Apollo Project Memo # 56

TO: Distribution
FROM: George W. Cherry
DATE: June 9, 1969
SUBJECT: What is LUMINARY 1B? Some Results of the 31st
Apollo Software Configuration Control Board Meeting

Figure 1. Keystroke Saving Extended Verb

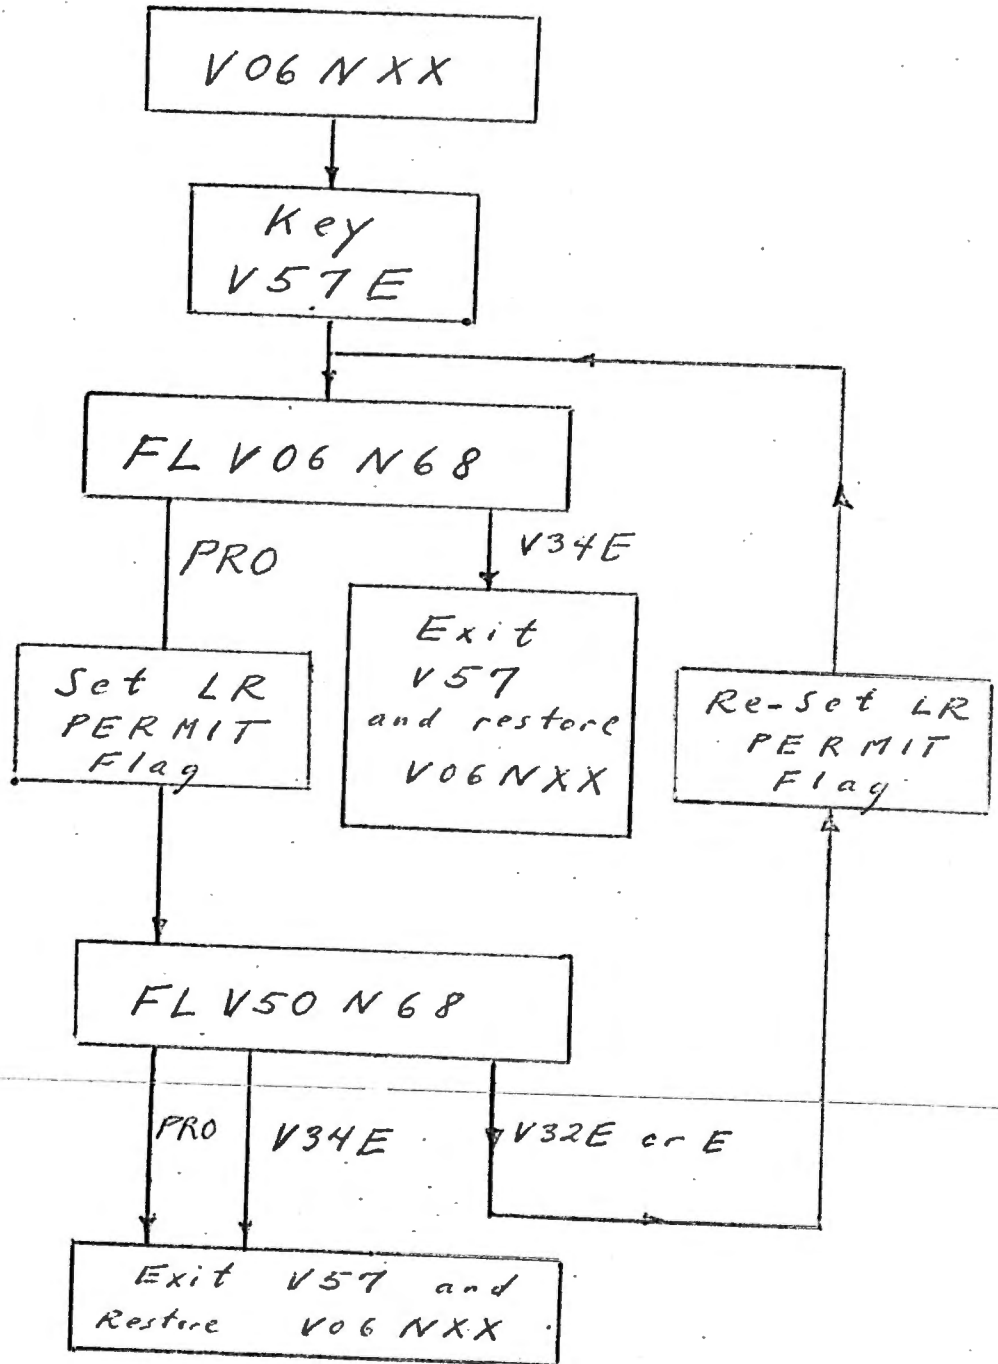
Reduce Keystrokes Required to Check and Approve LR Data.

It formerly took 19 keystrokes to display the difference between LR derived altitude and LGC inertial altitude, approve the incorporation of LR data, and then check the effect of incorporating the LR data. We have cut this down to 6. The PCR was slightly modified to give a definite LGC display indication to note the approval of LR data incorporation. The change is shown in figure 1.

Margaret Hamilton, please note the new scheme in figure 1 and try to so mechanize this to save computer time.
